REQUEST

Current Zoning: R-22MF (multi-family residential)
Proposed Zoning: UR-2(CD) (urban residential, conditional)

SUMMARY OF PETITION

**STAFF
RECOMMENDATION**

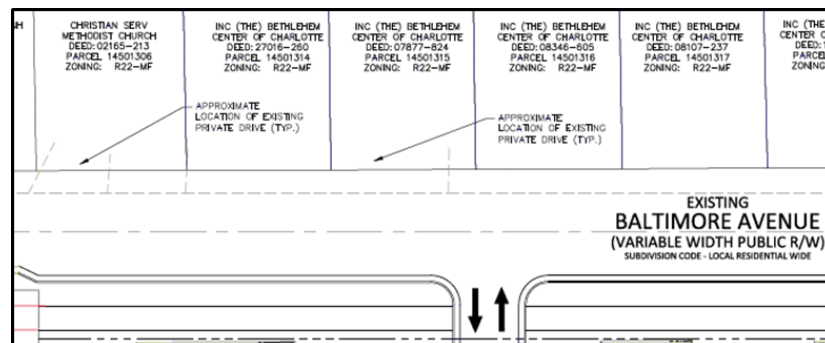
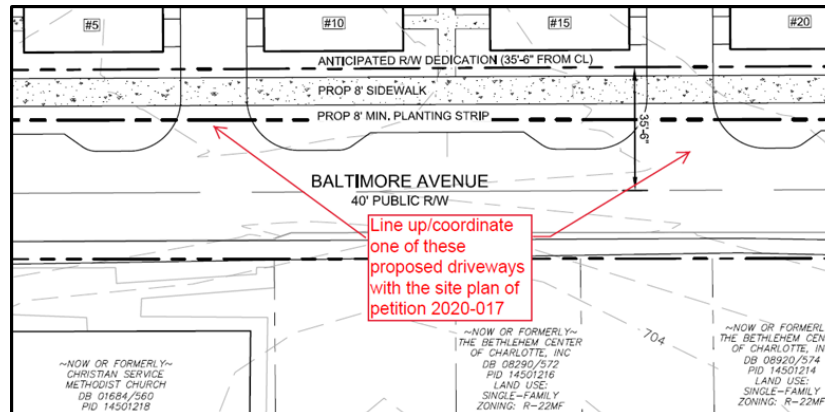
2. ~~Revise the site plan and conditional note(s) to construct a sidewalk connection to Remount Road with curb and gutter, in reference to the Vision Zero Action Plan and Charlotte WALKS. CDOT has notified Mecklenburg County of the possibility of the petitioner possibly attaining right of way and a construction easement to establish this connection. The proposed sidewalk connection will tie into the proposed improvements requested to rezoning petition 2019-017. PARTIALLY ADDRESSED. NEED TO CONFIRM CURB & GUTTER~~
